RE: SAP 14-159 Revision Request – Mixed Use Development

PROJECT SUMMARY

01 PARKING DECK SECTION.D'

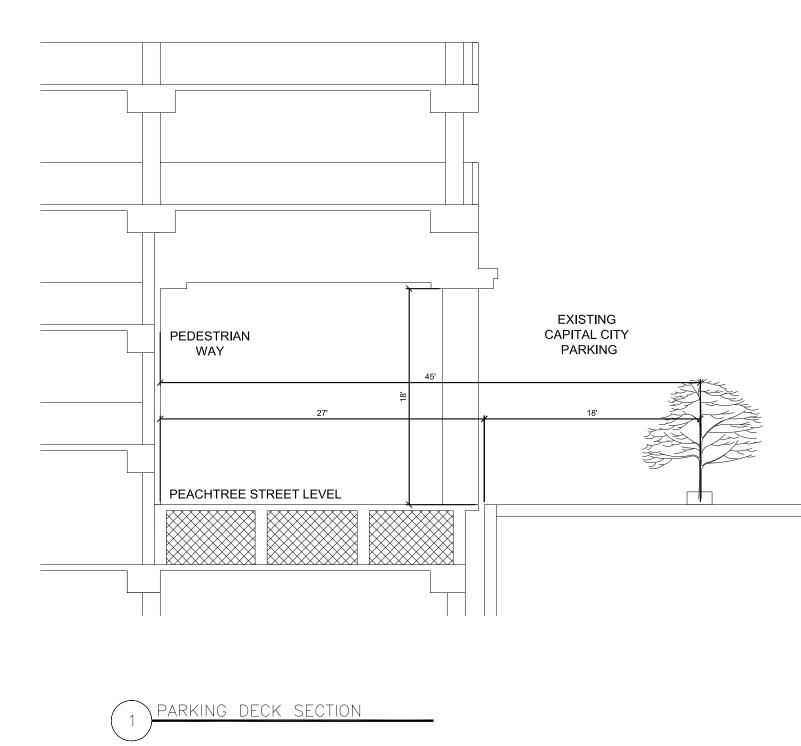
SAP 14-159 - Mixed Use Development was presented to the SPI-12 DRC on Wednesday October 1, 2014. Pursuant to DRC comments, the applicant would like to request an amendment to the SAP application that was submitted on Tuesday September 30, 2014 to remove the variation request for the pedestrian way clearance height.
